SEWAGE DISPOSAL SYSTEM

MARYLAND STATE DEPARTMENT OF HEALTH

ADDRESS Old Frederick Road, Woodstock, Md. 21163

ROAD 3218 Evergreen Way

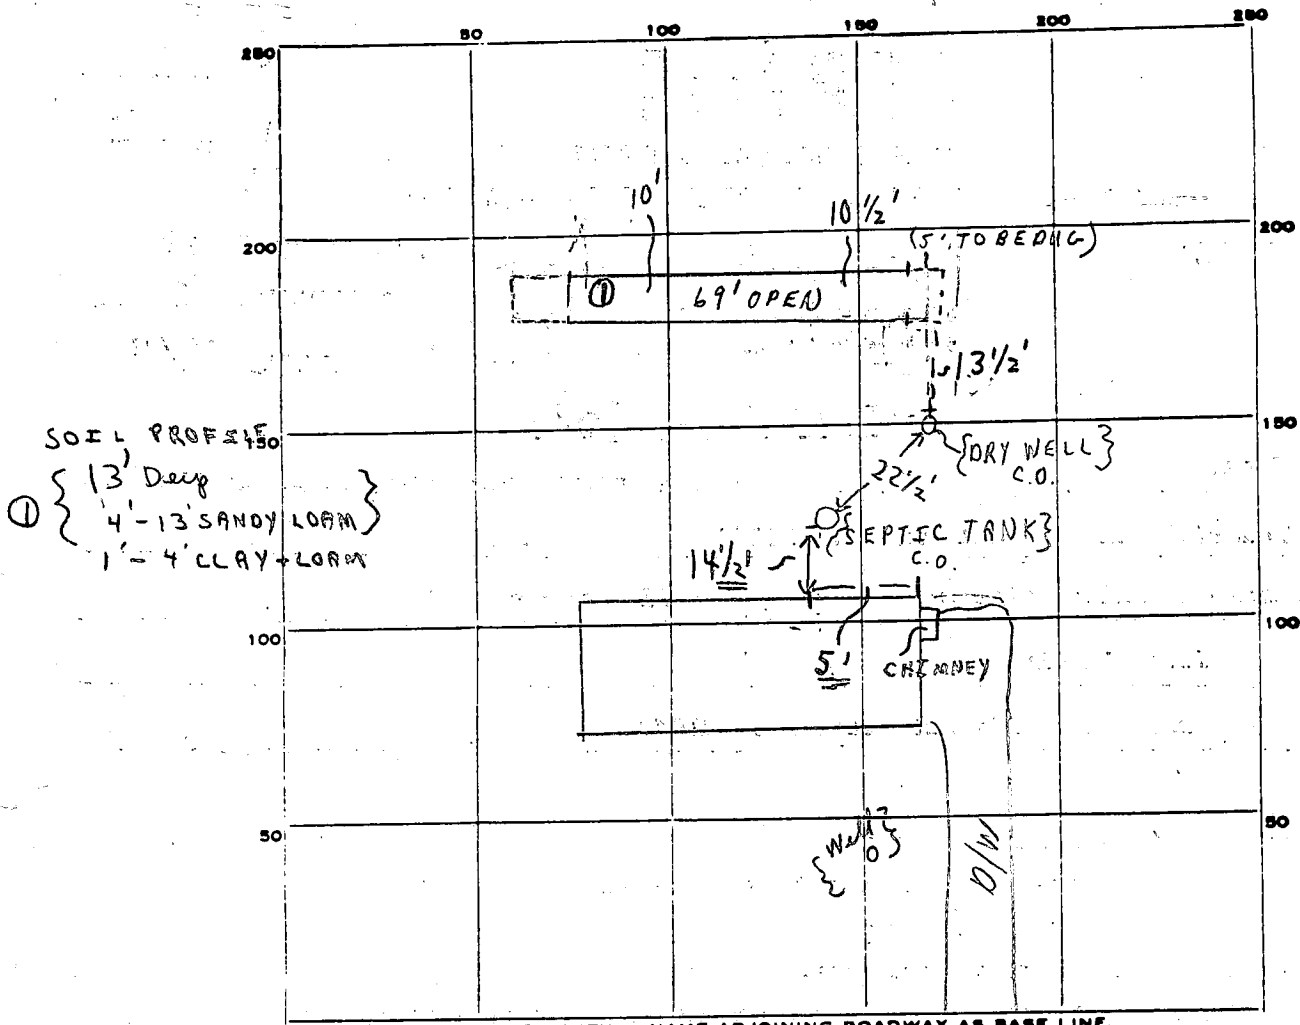
Notes - need approved clearouts to grade on septic tank & dry well. RS. Palmer F. Wine

TRENCH TIE FIELD, DEPTH 10'-10 1/2' FT. TRENCH WIDTH 2 FT. (Need more 6'-11' LENGTH)

REMARKS 8/6/81 HOLD FOR RESCHEDULE; 8/7/81 MAN CHECKED - SEPTIC TANK CLEANOUT ON ONLY (P.M.-OK) NEEDS TO BE CEMENTED INSIDE AT BASE

AND DRY WELL CLEANOUT ON; (D.P.M. - HOLE 13' DEEP DUG - OK FOR TRENCH. C.B.S. C.B.S.

8/7/81 (2) P.M. - TRENCH 69' LONG; OWNER TO VERIFY REST OF TRENCH-LENGTH; DEPTH; DEPTH OF STONE; TYPE OF PIPE USED; PARTIAL. C.B.S. 8/10/81 SYSTEM COVERED. - MR FADELY OWNER C.B.S.
